SUNDRY NOTICES AND REPORTS ON WELLS

Poker Lake Unit 318H

BOPCO L.P. respectfully request to ammend point four of the 8pt drilling program from the original APD that was approved on 11/21/2011. Point four of the drilling program will now read as stated in the attached page. The subsequent diagrams are also attached.

POINT 4: PRESSURE CONTROL EQUIPMENT (SEE ATTACHED DIAGRAM 2)

H2S contingency

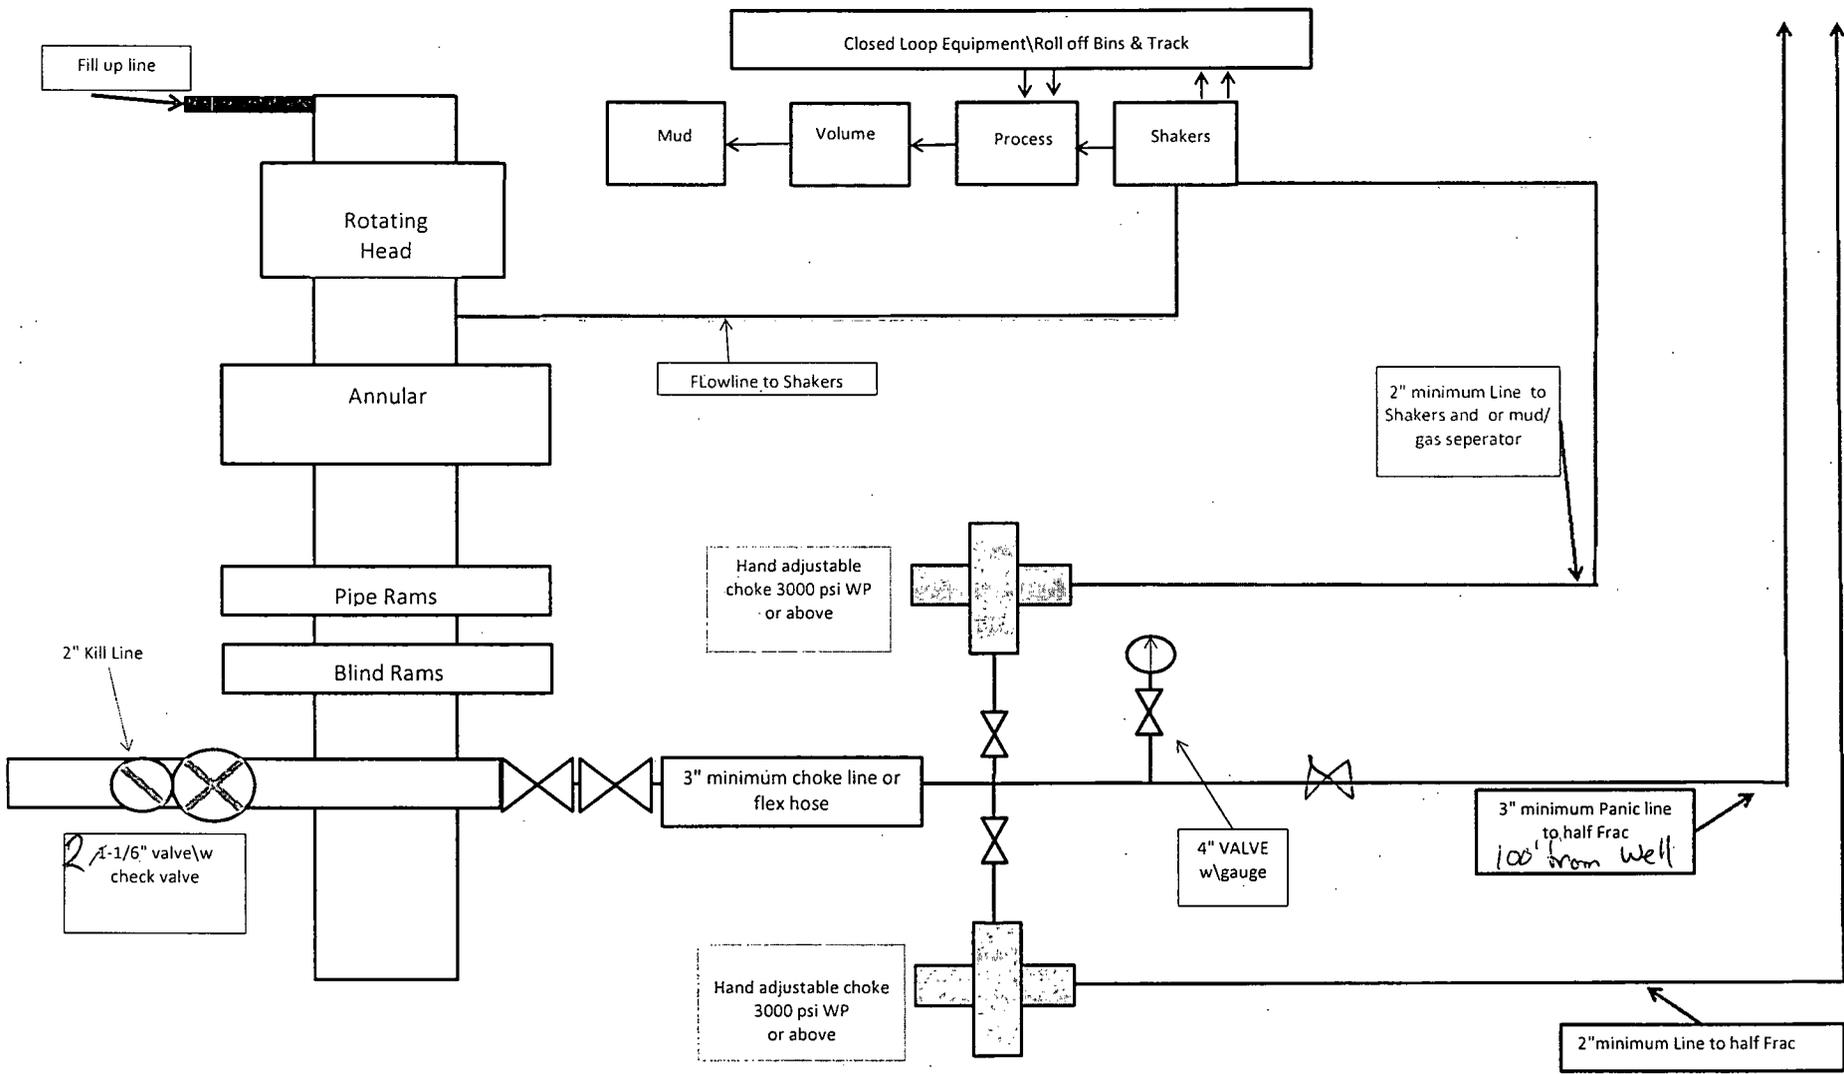
After running the 13-3/8" surface casing, a 13-5/8" BOP/BOPE system with a minimum rating of 3M will be installed, used, maintained and tested as per Onshore Order 2. In addition to the high pressure test, a low pressure (250-300 psig) test will be performed.

After running the 9-5/8" intermediate casing, a 13-5/8" or 11" BOP/BOPE system with a minimum rating of 3M will be installed on the 9-5/8" intermediate casing spool (8-3/4" open hole), used, maintained and tested as per Onshore Order 2. In addition to the high pressure test, a low pressure (250-300 psig) test will be performed.

After running the 7" intermediate casing, a 13-5/8" or 11" BOP/BOPE system with a minimum rating of 3M will be installed on the 9-5/8" intermediate casing spool (8-3/4" open hole), used, maintained and tested as per Onshore Order 2. In addition to the high pressure test, a low pressure (250-300 psig) test will be performed.

H2S monitors shall be installed prior to drilling out the surface shoe. If H2S is encountered in quantities greater than 10 PPM, the well will be shut in and H2S equipment will be installed, including a flare line that will be extended pursuant to onshore oil and gas order #6.

13-5/8" X 3-M BOPE (2 Rams and Rotating Head) & Closed Loop System Equipment Schematic Diagram 2

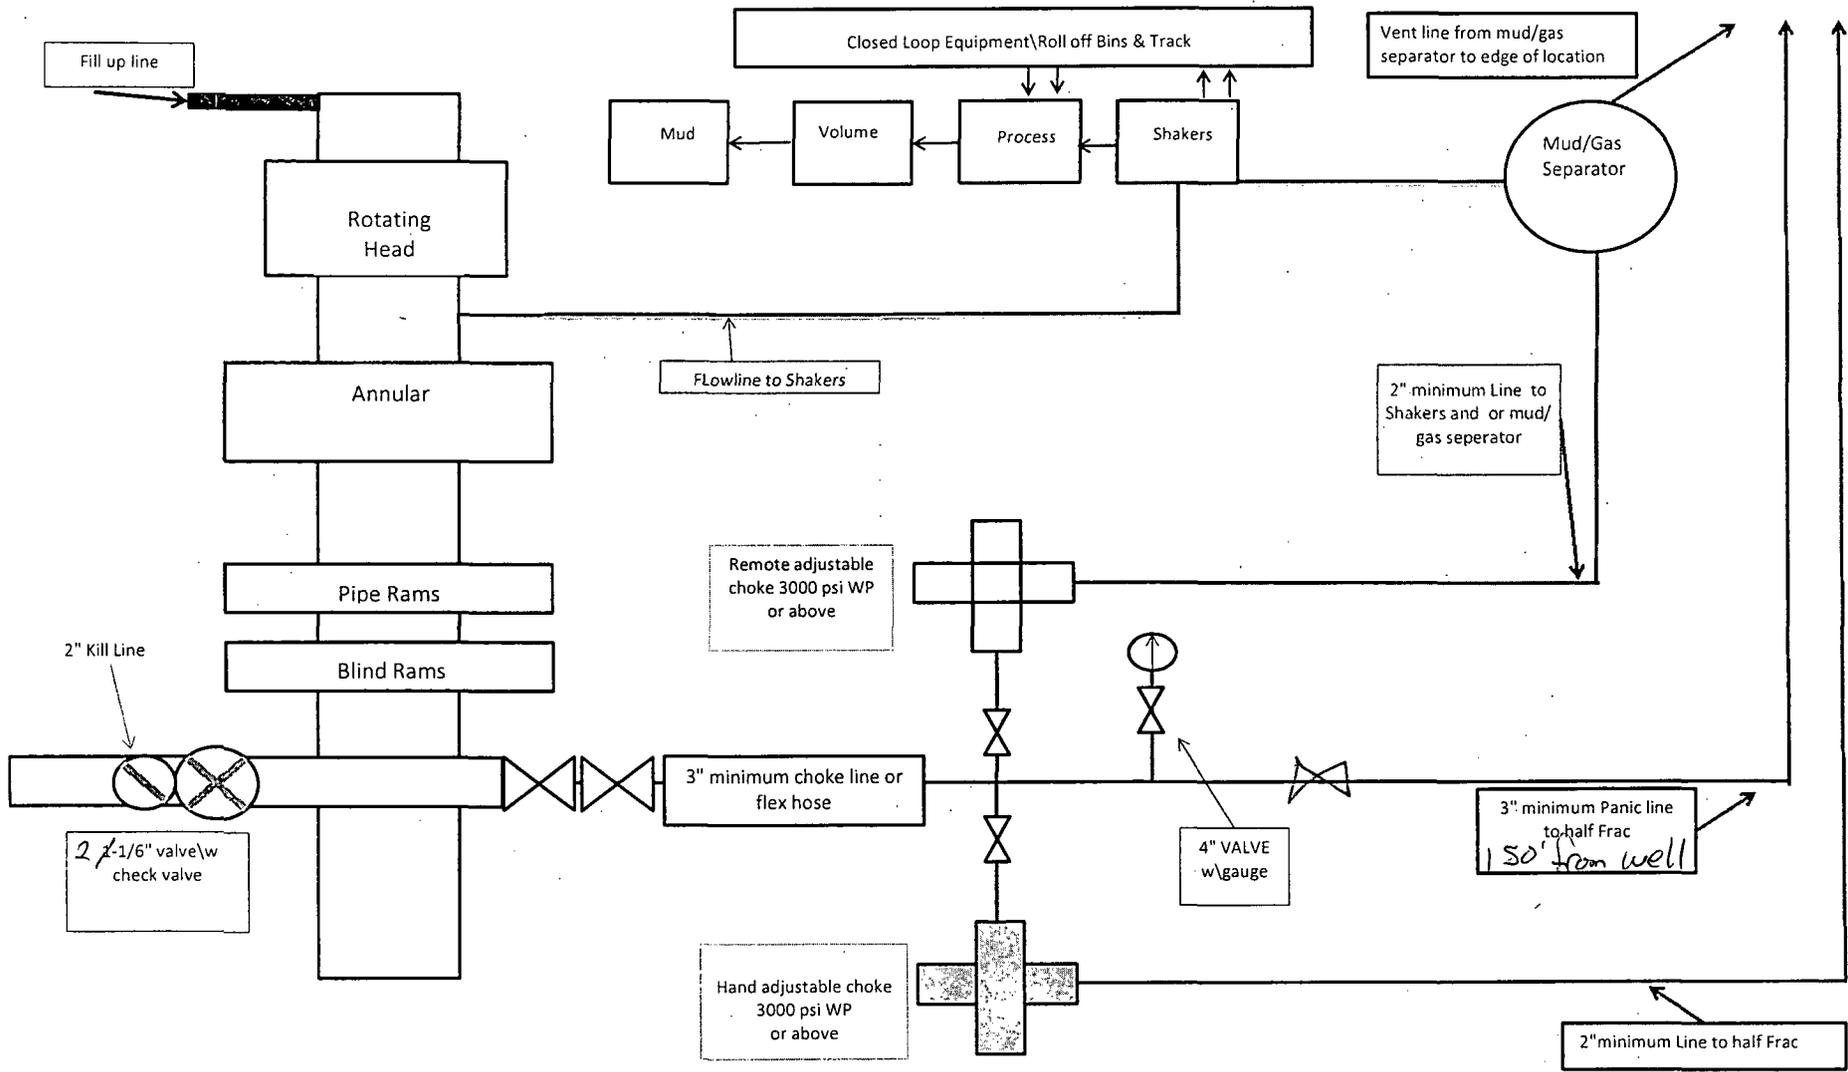
BOPCO, L.P. would like to request a variance to use an armored, 3", 5000 psi WP flex hose for the choke line in the drilling of the well if the rig is equip with hose. (See specification for hose that might be used, attached with APD exhibits). This is rig equipment and will help quicken nipple up time thus saving money without a safety problem. The hose itself is rated to 5000 psi ,and has 5000 psi flanges on each end. This well is to be drilled to 15,370 MD (7,722' TVD) and max surface pressure should be +/- 1915 psi as prescribed in onshore order #2 shown as max BHP minus 0.22 psi/ft. Thus, 3000 psi BOPE is all that is needed for this well. **Please refer to diagram 2 for choke manifold and closed loop system layout. If an armored flex hose is utilized, the company man will have all of the proper certified paper work for that hose available on location.**

Co-Flex line
Conditions of Approval

Variance approved to use flex line from BOP to choke manifold. Check condition of flexible line from BOP to choke manifold, replace if exterior is damaged or if line fails test. Line to be as straight as possible with no hard bends and is to be anchored according to Manufacturer's requirements. The flexible hose can be exchanged with a hose of equal size and equal or greater pressure rating. **Anchor requirements, specification sheet and hydrostatic pressure test certification matching the hose in service, to be onsite for review.** If the BLM inspector questions the straightness of the hose, a BLM engineer will be contacted and will review in the field or via picture supplied by inspector to determine if changes are required (operator shall expect delays if this occurs).
